Drawing Title
COVER SHEET

PROPOSED MIXED USE DEVELOPMENT

47-50 THE ESPLANADE ETTALONG BEACH

S75W SUBMISSION

Drawing Title
EAST & WEST ELEVATIONS

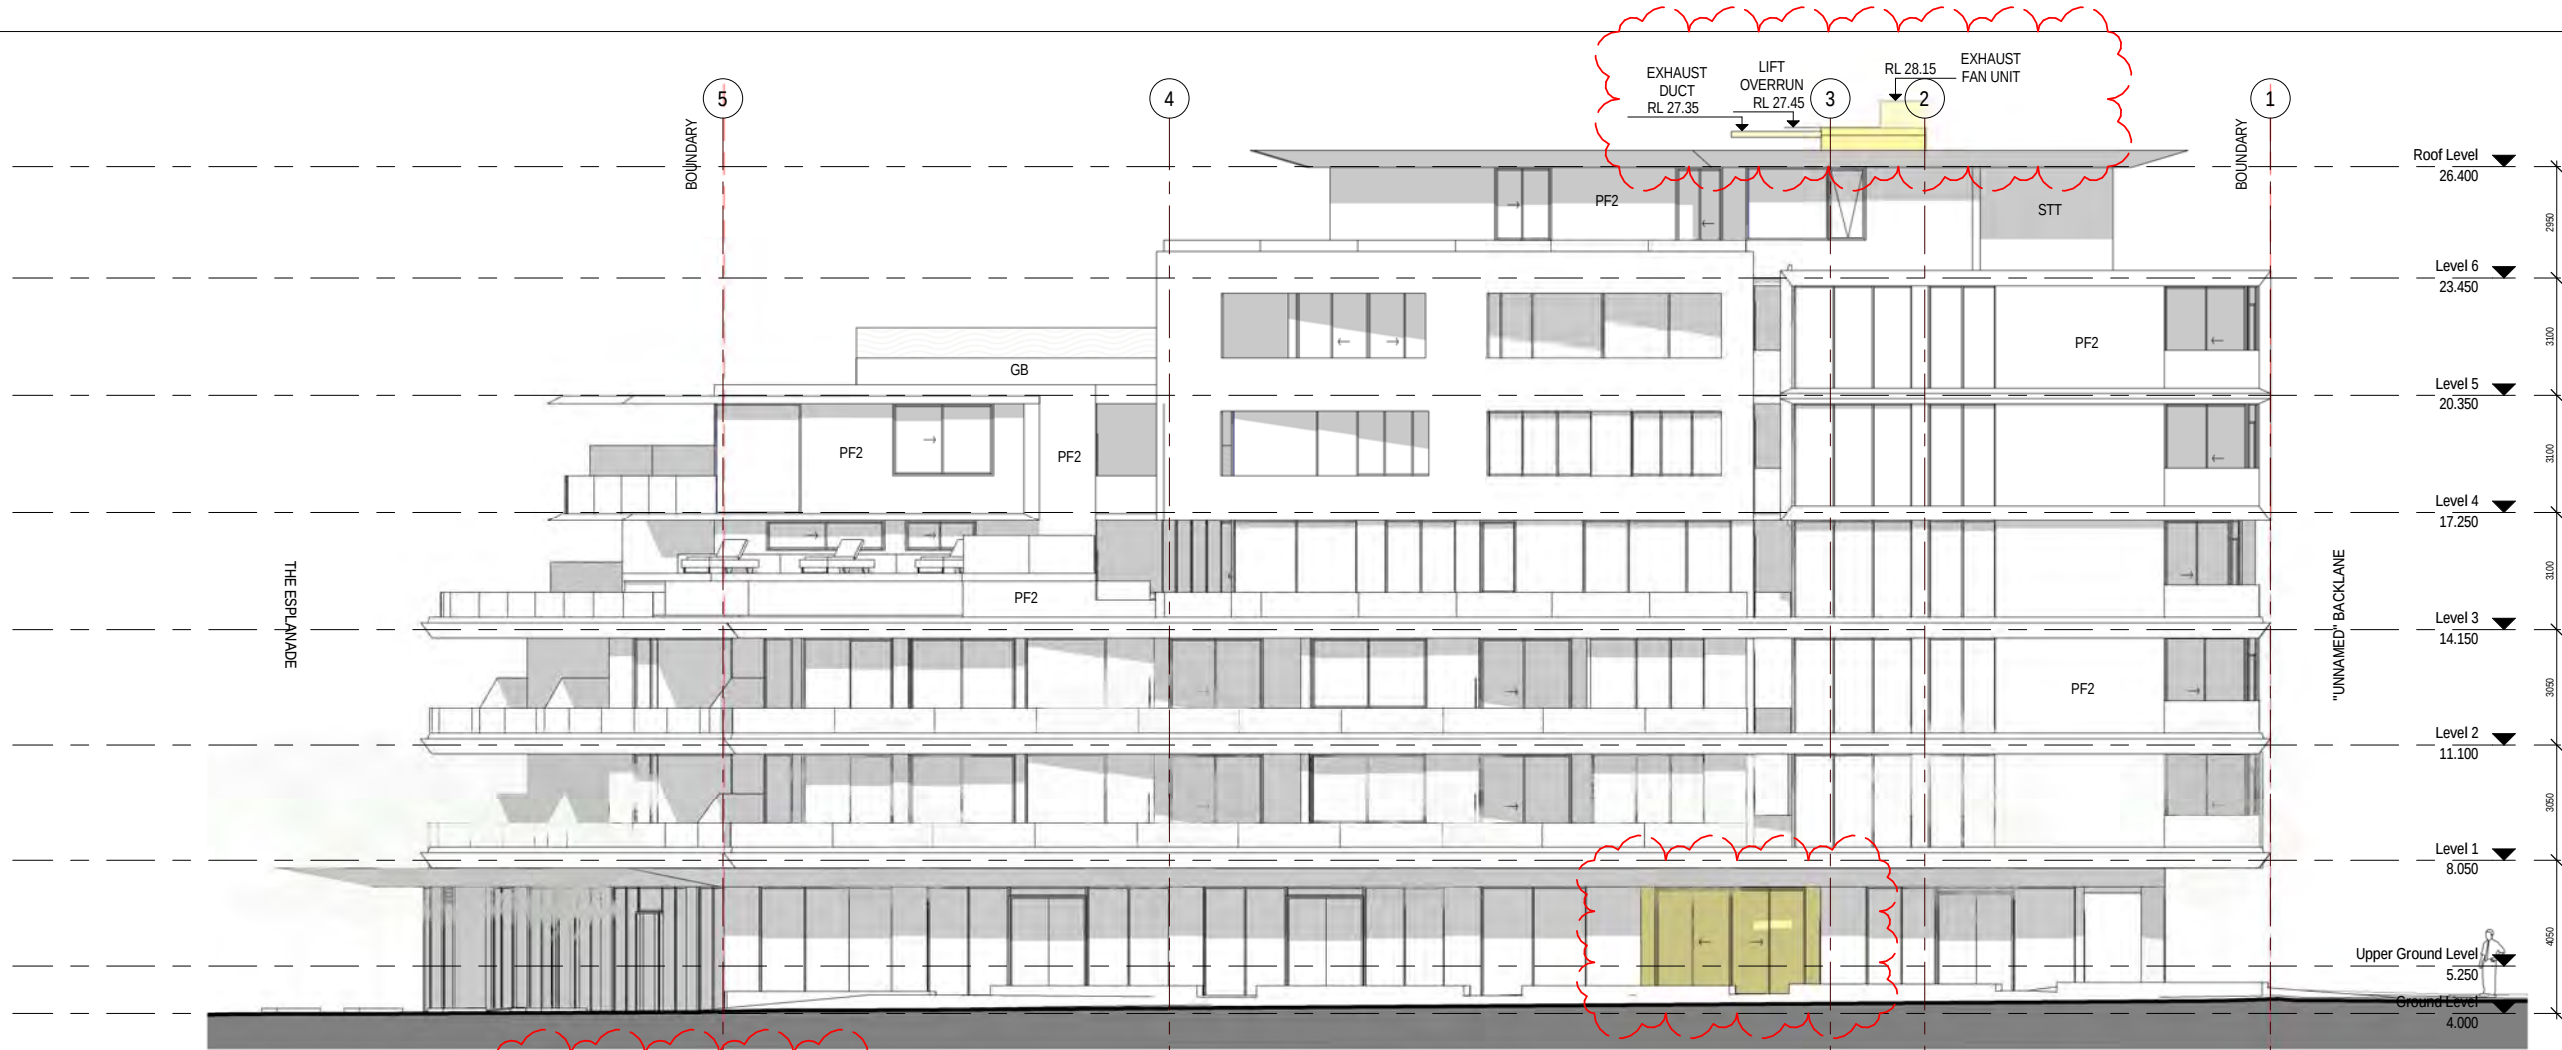
- LOBBY 1 & 2 ENTRY DOOR REVISED
- FIRE BOOSTER DOORS ADDED / WALL REVISED
- LIFT OVERRUN AT ROOF LEVEL
- EXHAUST FANS ADDED ON ROOF

Drawing Title
SHADOW DIAGRAMS - WINTER SOLSTICE

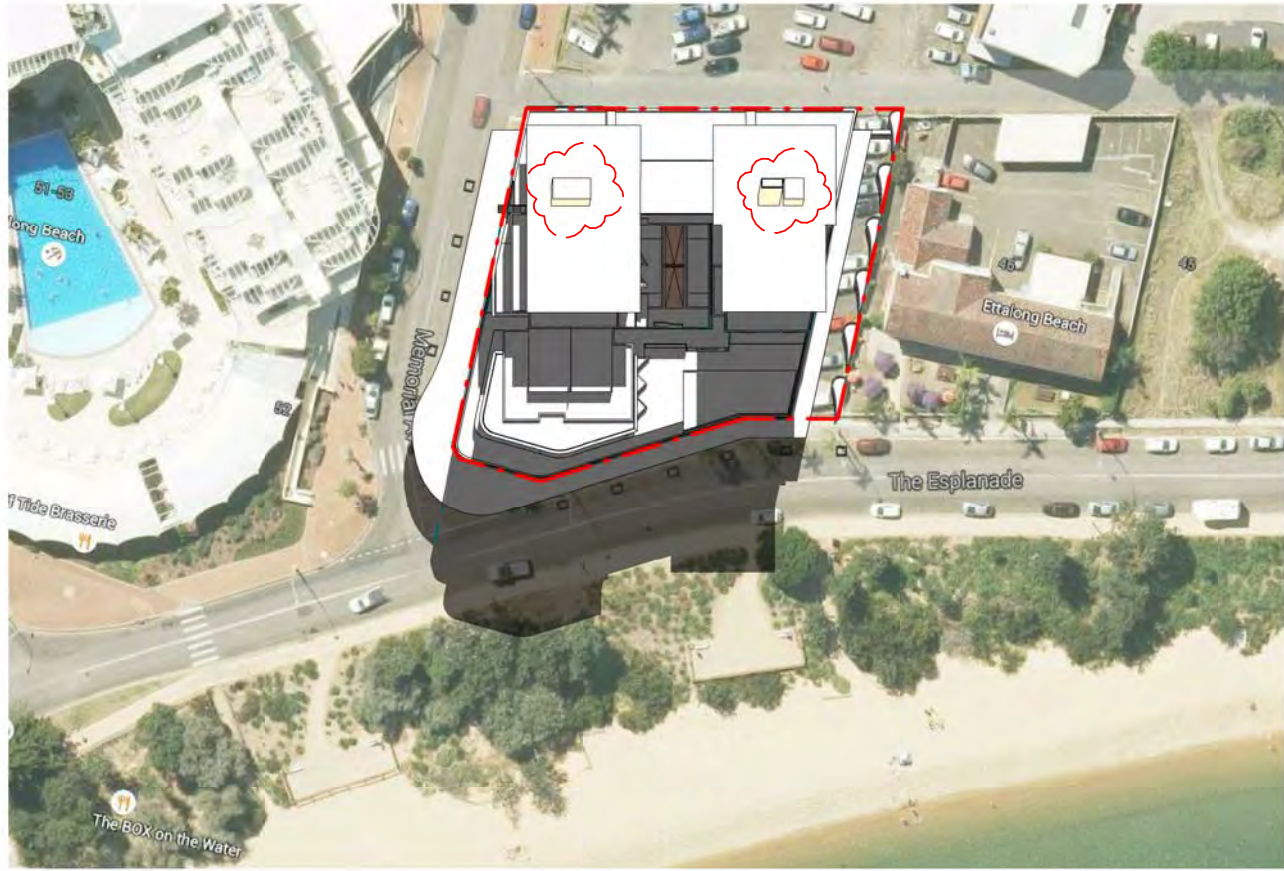
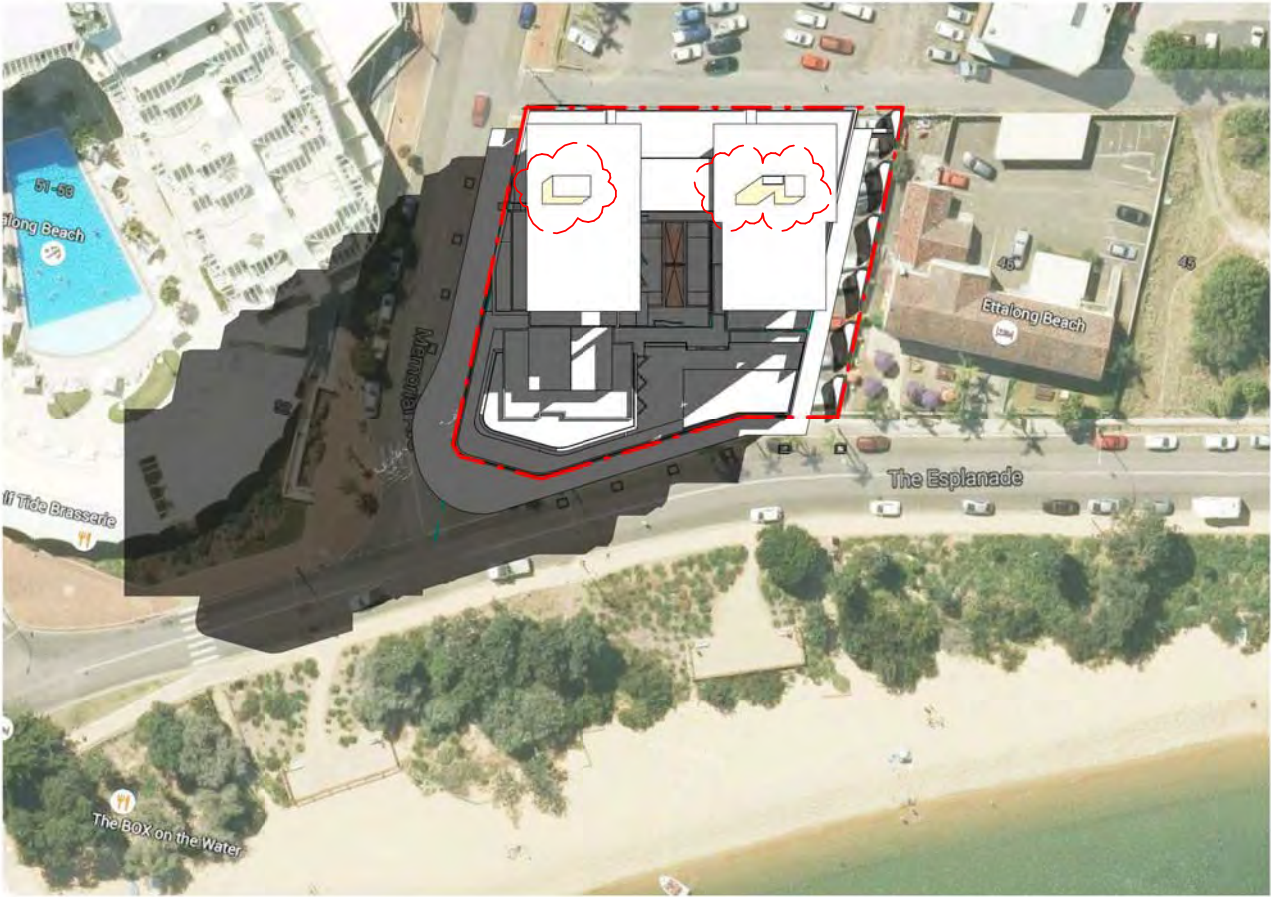
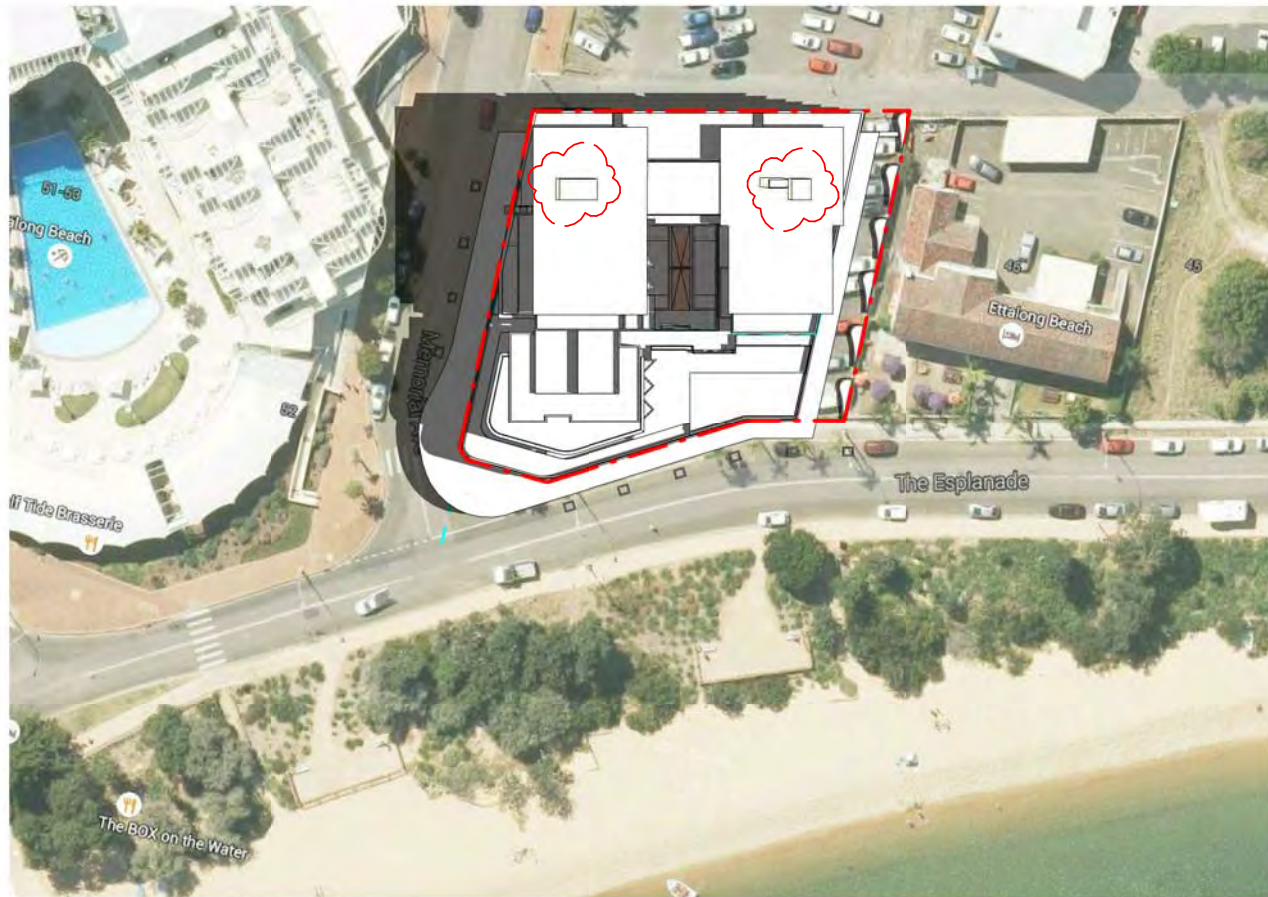
* ADDITIONAL SHADOWS CAST BY LIFT OVERRUNS LIMITED TO ROOF TOP ONLY
AS INDICATED BY DIAGRAMS. DO NOT AFFECT GROUND LEVEL AREAS

- LIFTOVER RUNS ADDED
- LIFT OVERRUNS & EXHAUST FAN UNIT SHADOW ADDED
- SHADOW LEGEND REVISED

Drawing Title
GFA CALCULATION

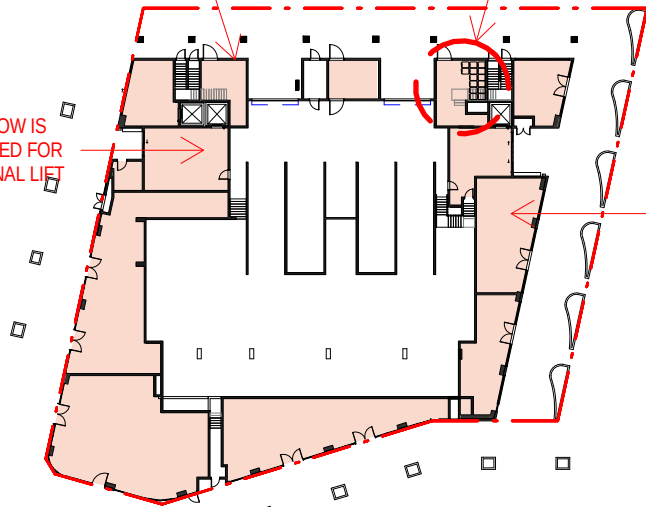
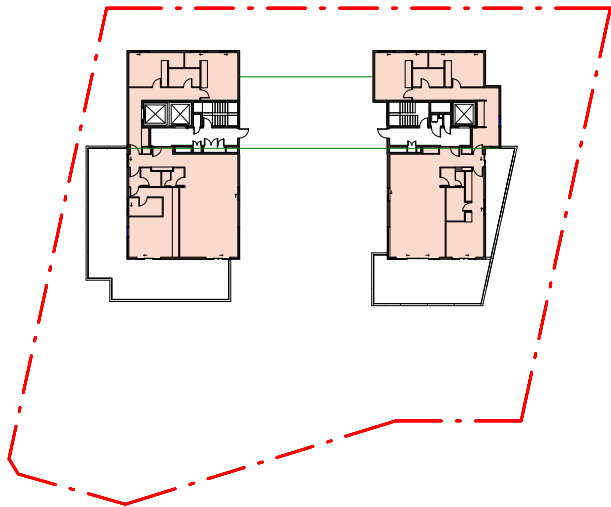
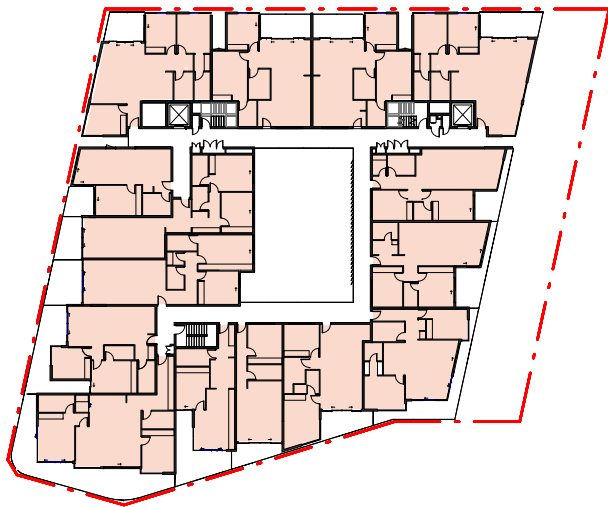
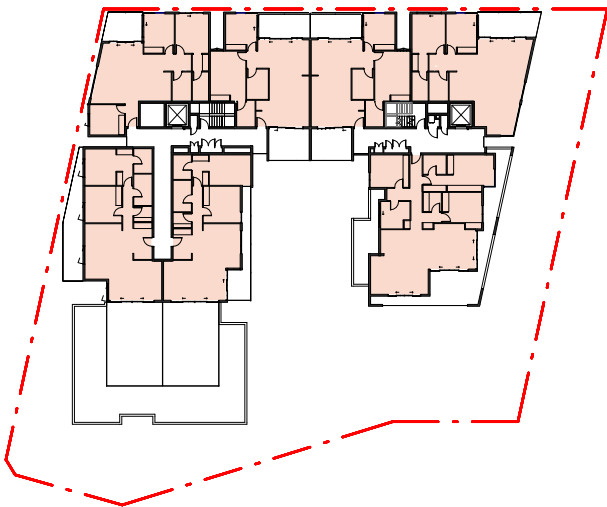
GARBAGE ROOM INCREASED TO PROVIDE SUFFICIENT SPACE FOR BINS

LOBBY NOW IS INCREASED FOR ADDITIONAL LIFT

BASEMENT WASTE ROOM RELOCATED TO GROUND. GFA INCREASED (29.46M²)

COMMERCIAL MERGED WITH THE CORRIDOR SPACES TO INCREASE SHOP DEPTH

S75W AMENDMENTS:
GFA REVISED

BASEMENT
FLOOR PLAN (COMPARISON SHEET)

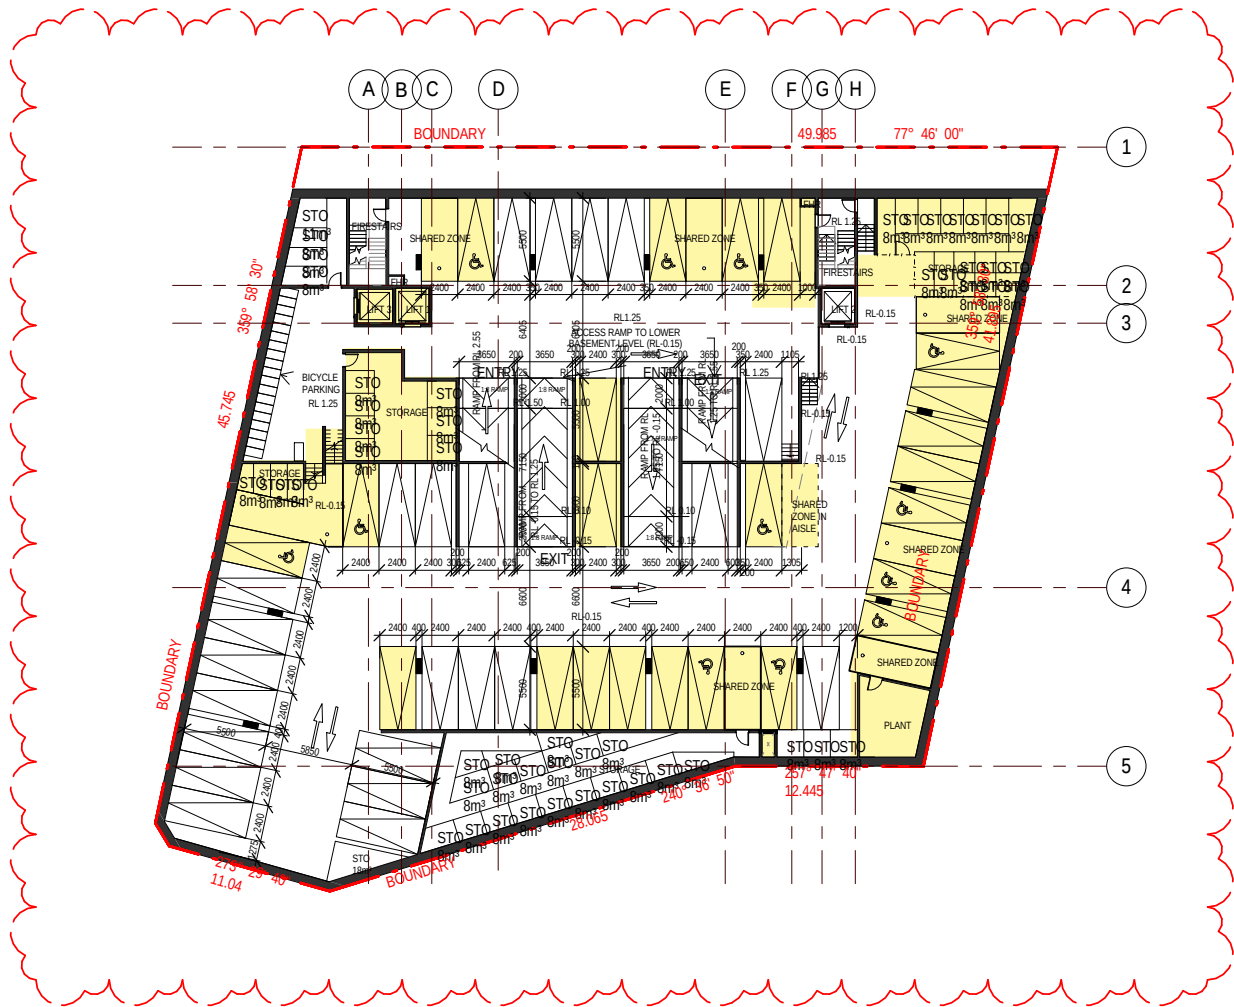
- STORAGE AREAS REVISED
- LIFT03 ADDED / LIFT 01 RELOCATED
- CARPARK LAYOUT REVISED
- CARPARK SCHEDULE REVISED
- GARBAGE ROOM ON BASEMENT REMOVED
- SECTION LINE RELOCATED

GROUND FLOOR PLAN

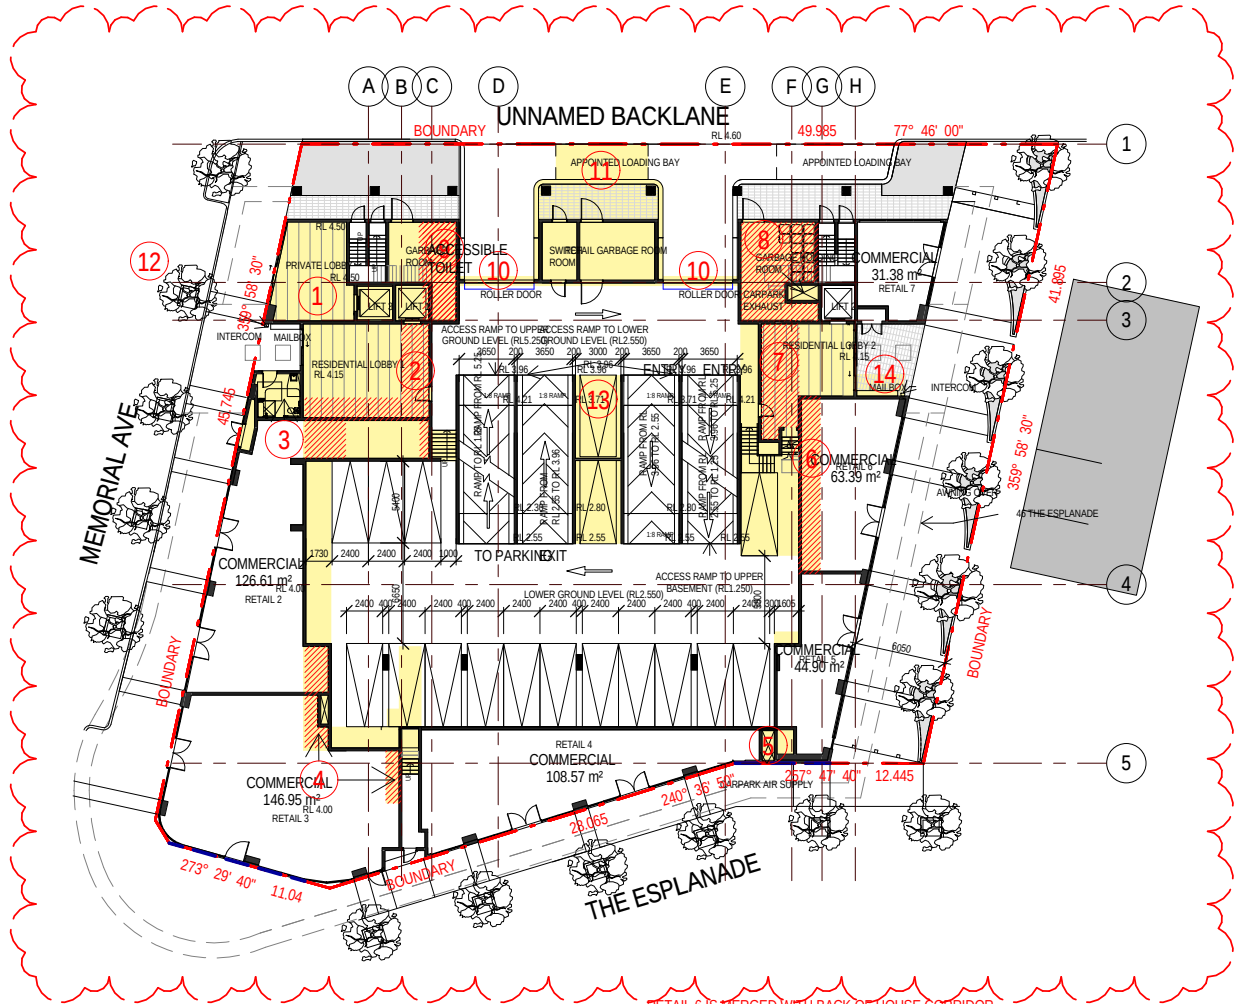
- ⑤ CARPARK AIR SUPPLY SHAFT ADDED
 - ⑥ RETAIL 6 MERGED WITH BACK OF HOUSE CORRIDOR TO INCREASE SHOP'S DEPTH
 - ⑦ RESIDENTIAL LOBBY 2 AREA INCREASED TO IMPROVE ITS SPATIAL QUALITY OF THE SPACE

- ⑪ APPOINTED LOADING BAY REDUCED TO 1 DUE TO THE LENGTH OF THE KERB
 - ⑫ SIGHTLINE SECTION MARKERS ADDED
 - ⑬ CARPARK LAYOUT REVISED AS VEHICLE RAMPS RELOCATED

- ⑭ MAILBOX & INTERCOM ADDED
 - ⑮ COMMERCIAL PARKING CALCULATION REVISED
